CPED STAFF REPORT

CPC Agenda Item #1
 March 24, 2014
 BZZ-6442

Property Location: 4255-59 Sheridan Avenue S
Project Name: 4255 Sheridan
Prepared By: [Kimberly Holien](#), Senior Planner, (612) 673-2402
Applicant: 4255 Sheridan, LLC (Paul Blomquist and Kristin Eggerling)
Project Contact: Carl Gauley of Julie Snow Architects
Request: To construct a four-story residential building with three dwellings units.
Required Applications:

NORTH
 1 GRADING AND DRAINAGE PLAN
 C5.0
 0 10' 20' 30'
 1"=10'

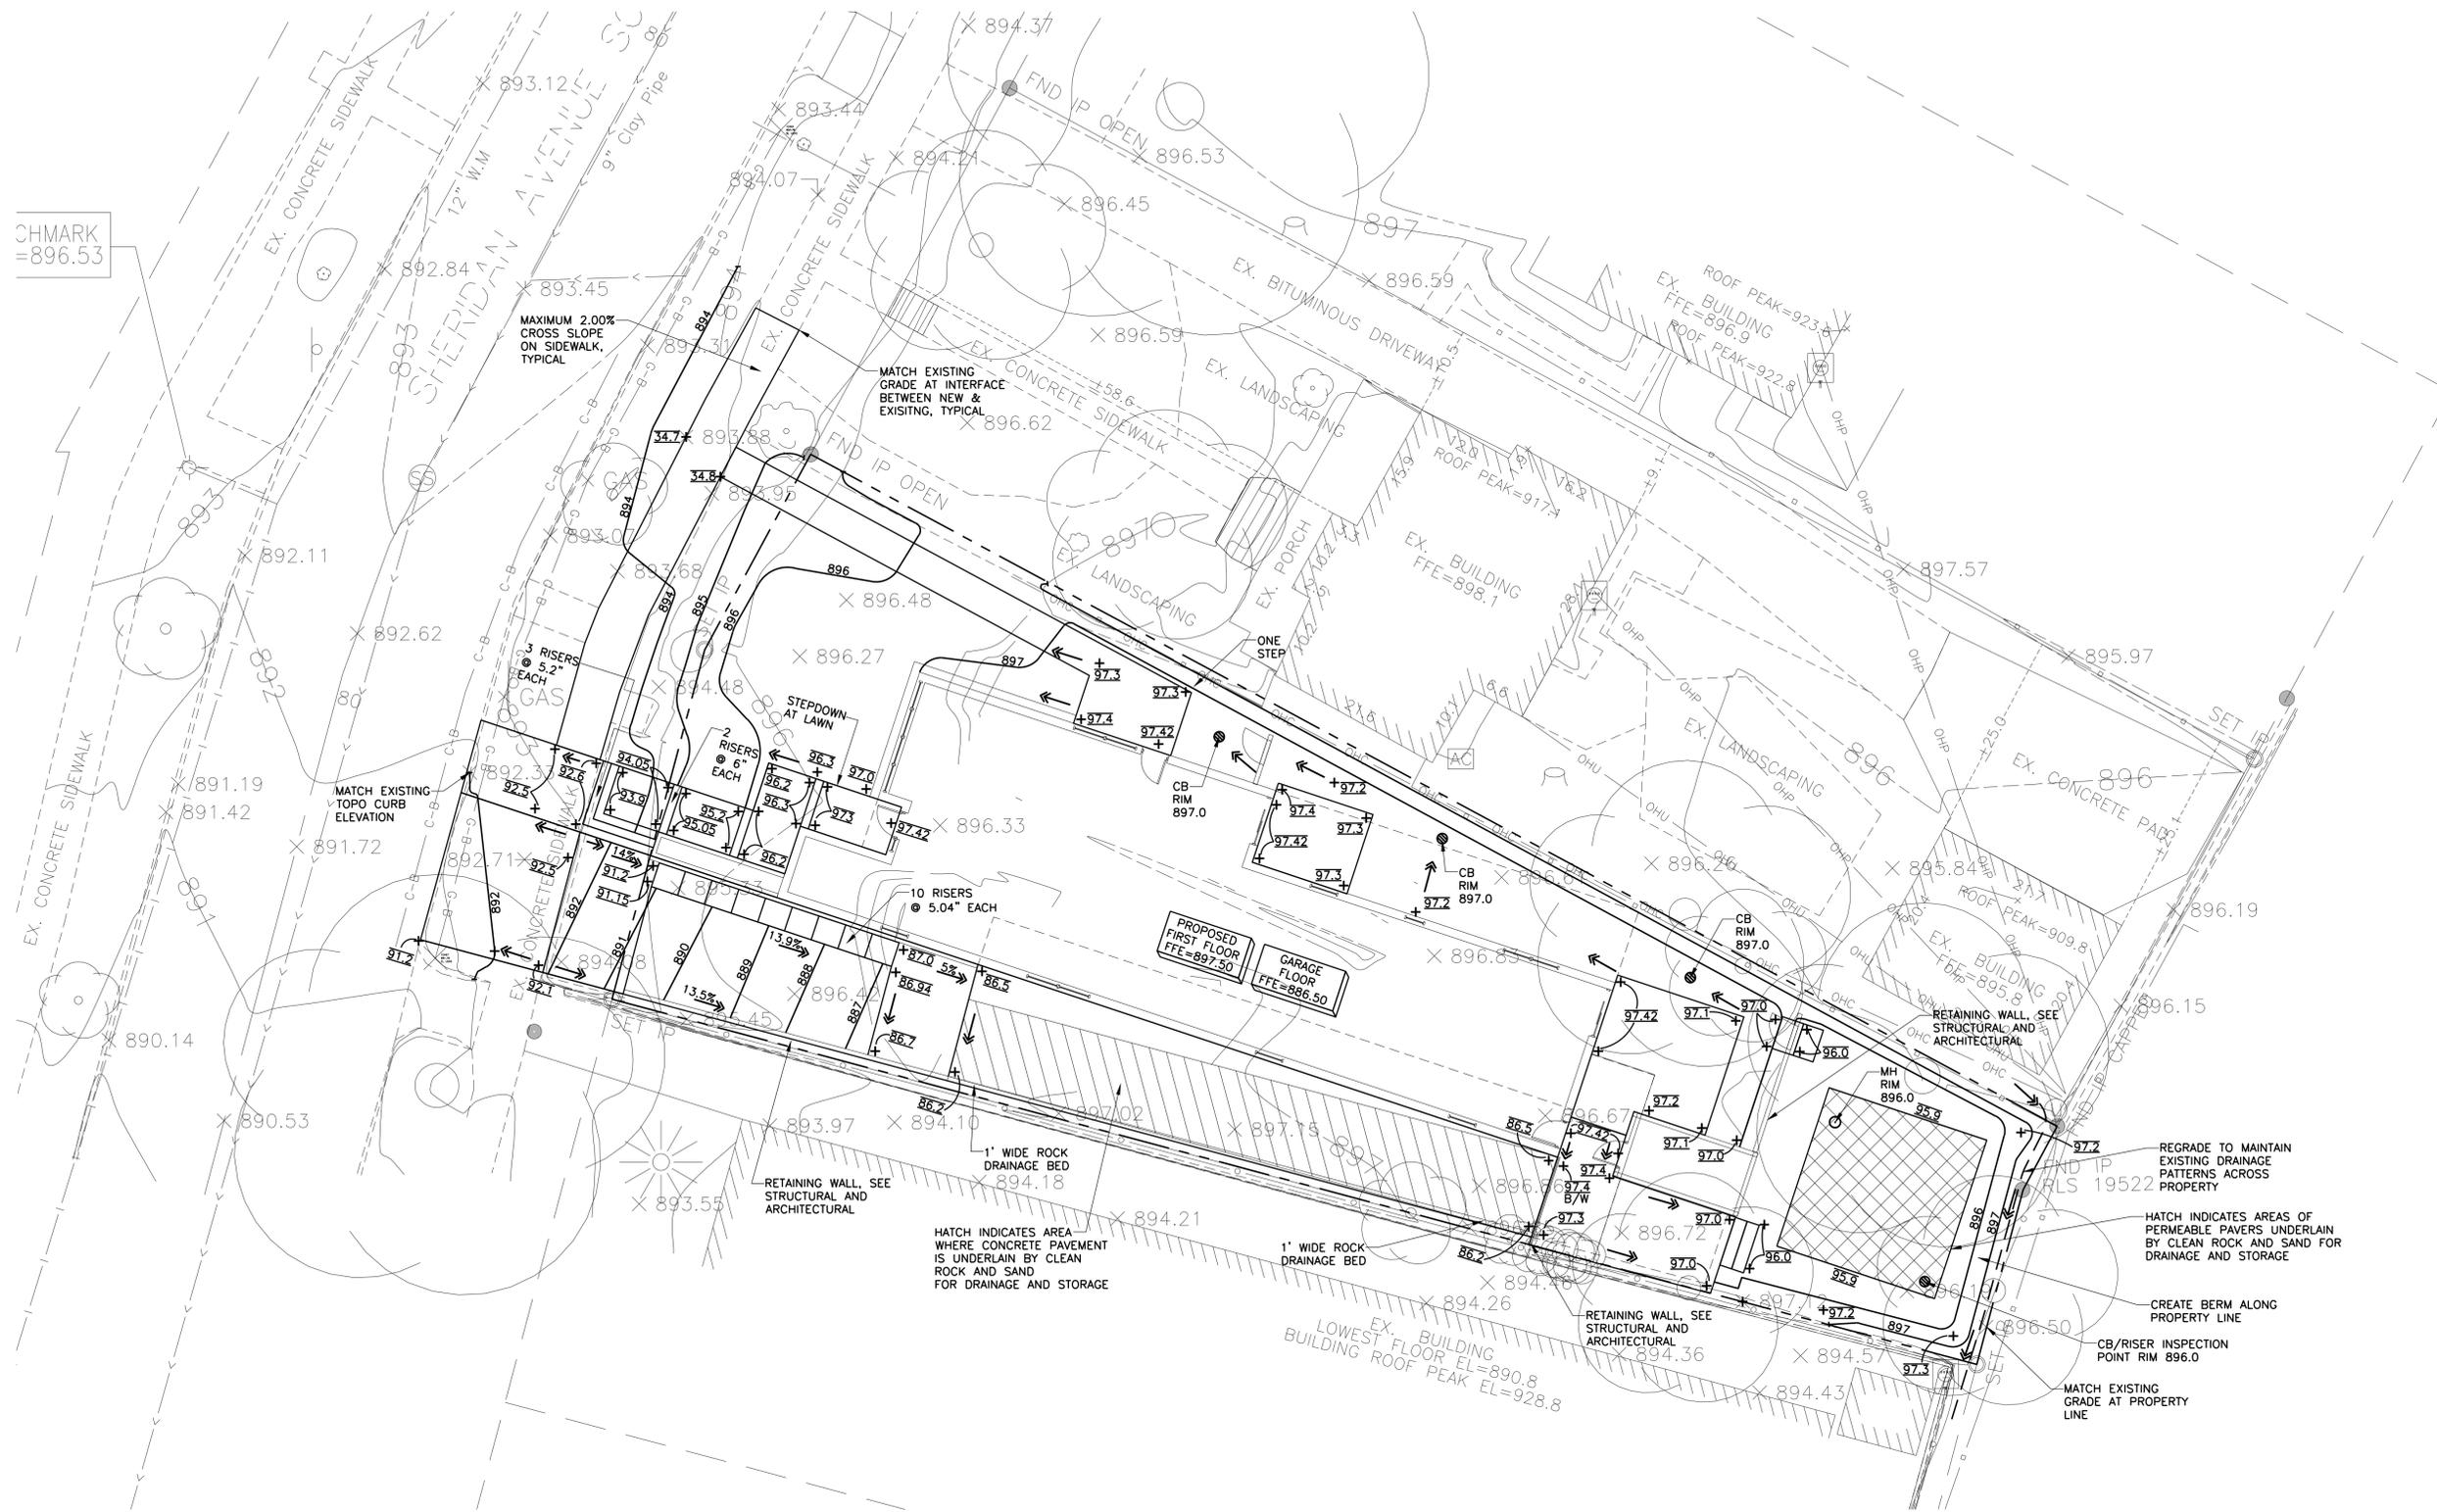
- Surface Drainage: Please provide stormwater modeling calculations identifying the high water levels expected for the various low spots and storage areas proposed with the project. The stormwater runoff must be managed in a manner that does not negatively impact adjacent properties or right-of-way. Any off-site drainage onto the property should also be identified and incorporated into the modeling. Please include any supporting documentation to evaluate the modeling (storage details, geotech reports, etc.)

- The emergency overflow for the permeable paver/stormwater storage area must be shown on the plan. The emergency overflow must be designed in a manner that does not negatively impact adjacent properties.

- The existing drainage pattern for the site, including off-site drainage that enters the property, should be clearly shown on the plans. The proposed project should not negatively impact any existing off-site drainage. The proposed berm along the east property line may impede the existing drainage pattern.

1 SITE & LANDSCAPE PLAN
SCALE: 1" = 10' - 0"

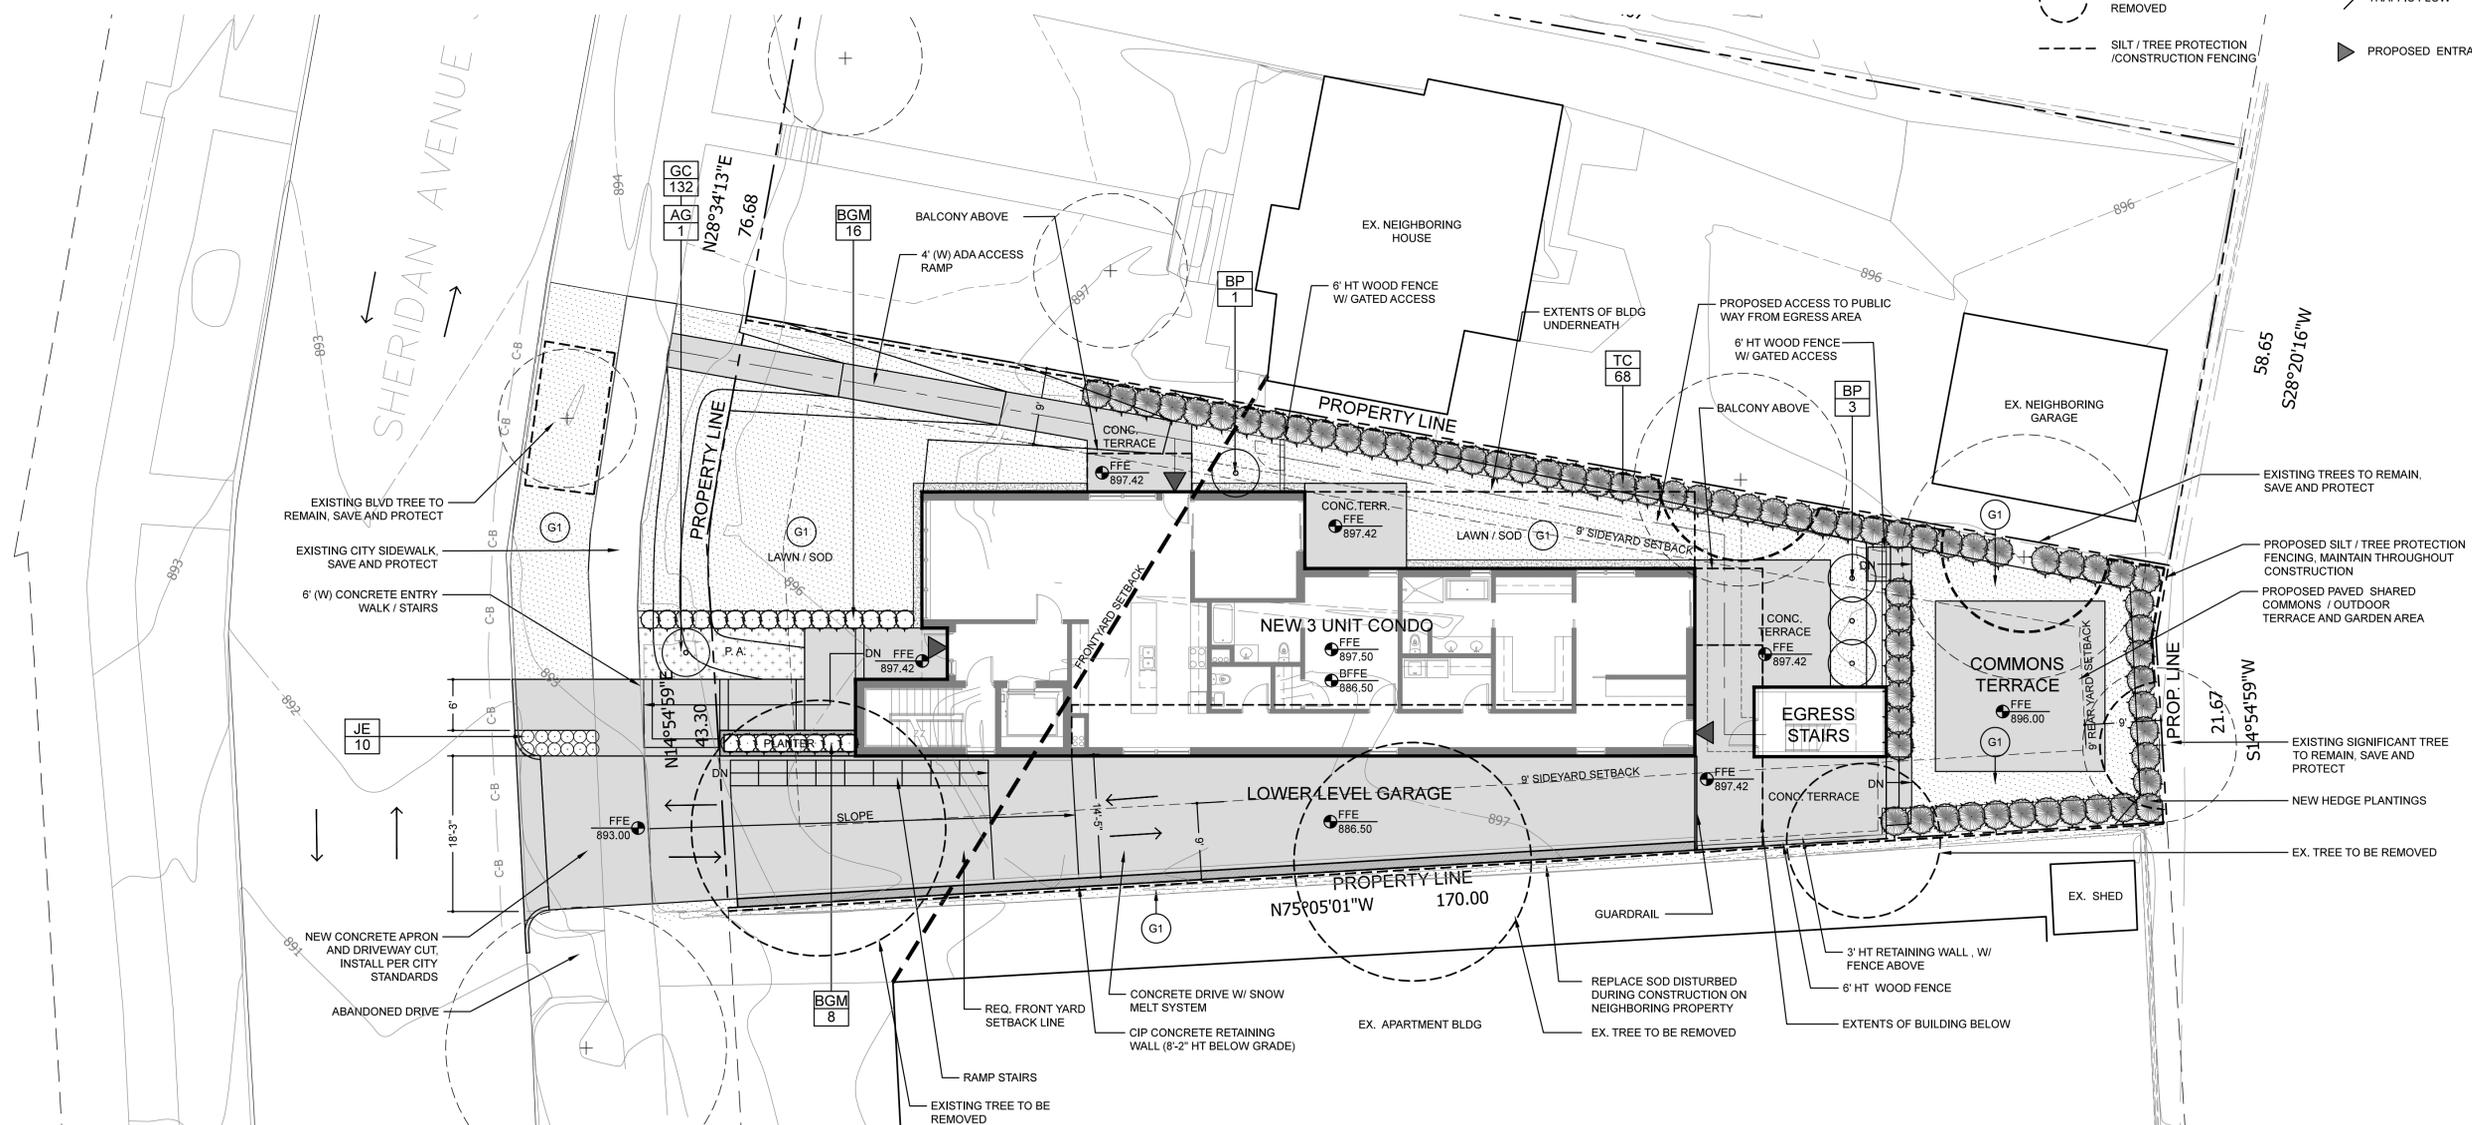
- Typically, proposed sidewalks, curbs, and driveway aprons are detailed on the Grading Plan or a specific Civil Site Plan. The current site plan submittal includes these details on Sheet L1.0 (Site and Landscaping Plan) which could be confusing to contractors.

- Removal of an existing curb cut is noted on Sheet L1.0 of the plans but not identified on Sheet C2.0 (Site Demolition Plan). If the curb cut is intended for removal it shall be clearly noted on the Site Demolition Plan.

- All Public sidewalks fronting the Project along Sheridan Ave. S. is noted and detailed on Sheet C2.0 (Site Demolition Plan) for removal, but identified on Sheet L1.0 to be saved and protected. The Applicant shall clarify the intent to remove or save sidewalk on all related plan sheets.
